## **REMARKS**

CONTAINMENT DEVICE AND METHOD FOR HOSE BIBS AND THE LIKE  
Annotated Marked-Up Drawings  
Patent Serial No. 10/748,768  
Inventor: Commeville et al. Atty Docket No. 31141-2  
Response to Office Action (dated 12/16/04)  
Contact: Troy J. Cole (317) 634-3456

Fig. 3

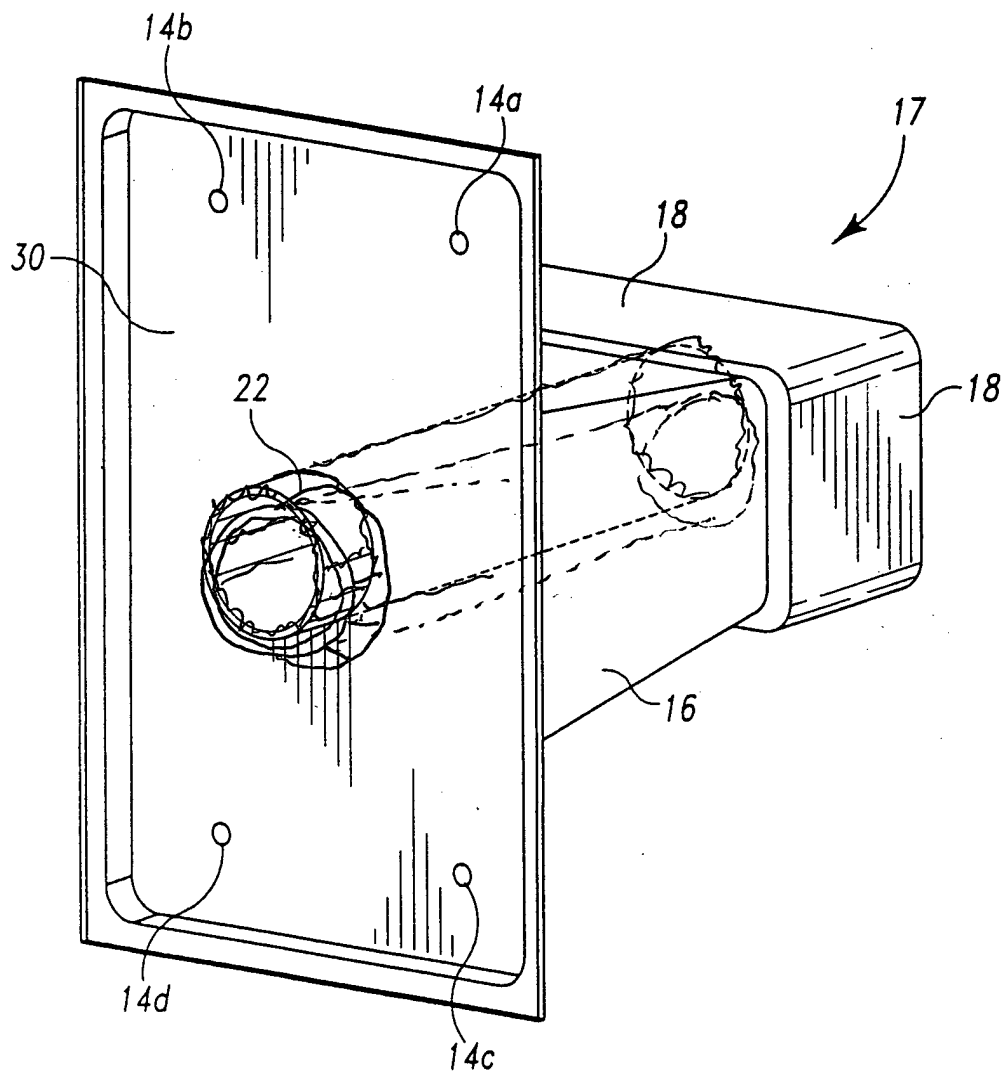
The Office Action rejected FIG. 6 for the failure to indicate that the hose bib illustrated is prior art. In addition, the drawings were objected to because in FIG. 3 hole 22 was incorrectly extended out of middle portion 16. The Applicants have amended the drawings in light of the Office Action suggestions. The designation (Prior Art) has been added to FIG. 6. The Applicants respectfully traverse the objection to FIG. 3. All of the lines for the hole 22 were dashed, indicating the structure is hidden within the middle and front portions. The Applicants, however, have amended FIG. 3 to make the perspective more accurate. The new drawings are included as Replacement Sheets in Appendix A and the changes are highlighted in the Annotated Marked-Up copies in Appendix B.

The attached sheets of drawings include changes to FIGs. 3 and 6 and replace the original sheets for FIGS. 3 and 6. In FIG. 3 the hole 22 has been revised to no longer extend out of the middle portion 16 and the designation (Prior Art) has been added to FIG. 6.
